Case #: ZBA 2007-63-R3 (2/2016)

PLANNING STAFF REPORT

Site: 70 Inner Belt Road

Legal Notice: Applicant & Owner CoreSite Real Estate 70 Inner Belt, LLC seek a revision to Special Permit with Site Plan Review (SPSR) (ZBA2007-63) under SZO §5.3.8 in order to alter the site plan for mechanical equipment. The original SPSR was for the expansion of an existing 22,667 sf data storage use (§7.11.15.1.c) within the second floor of an existing building for a total of 61,436 s.f. Prior revisions include ZBA 2007-63-R0308, ZBA 2007-63-R0808 & ZBA 2007-R2(8/2011) which consisted of increasing the use by approx 141,000 sf and altering the site and façade. IA zone. Ward 1.

70 Inner Belt Rd: View of the location of the proposed mechanical equipment from Inner Belt Road (above) and from an aerial view (below).

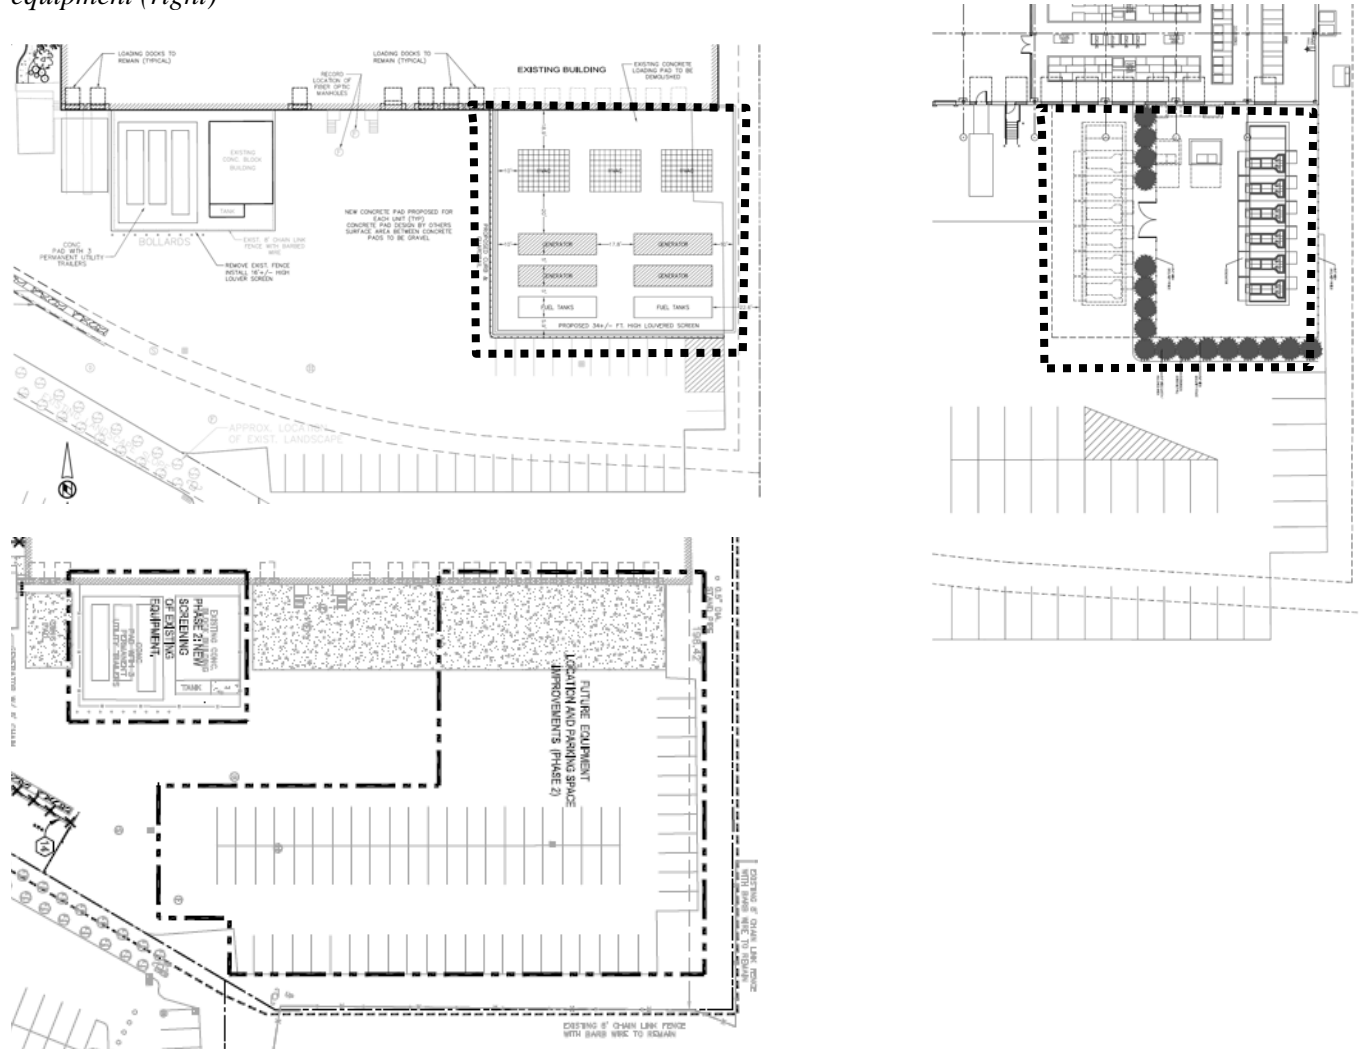
In the revised proposal the generator is the tallest equipment and is depicted on the submitted elevation as "generator beyond". The generator is 14'-2" tall and sits on a concrete slab that is 6" above existing grade for a total height of approximately 14'-8". There would be an 8 foot fence and evergreen trees surrounding the equipment to protect and screen it.

The surrounding area is industrial in nature and the mechanical equipment will not be detrimental to the existing neighborhood. On the other hand, the Inner Belt neighborhood is an area that is marked as an area to transform in SomerVision and new development should be designed with future change in mind. The mechanical equipment will be quite large and tall. Substantial evergreens will soften the edge of this equipment area. The 8 foot fence is setback from the street, will serve a security purpose and will be located behind the trees. The height of the fence should be allowed as part of this special permit revision

per SZO §10.7.1. The mechanical equipment that is currently on the site is more visible from the street than the proposed equipment. This existing equipment should be screened as was stated that it would be on the plans for the 2011 approval.
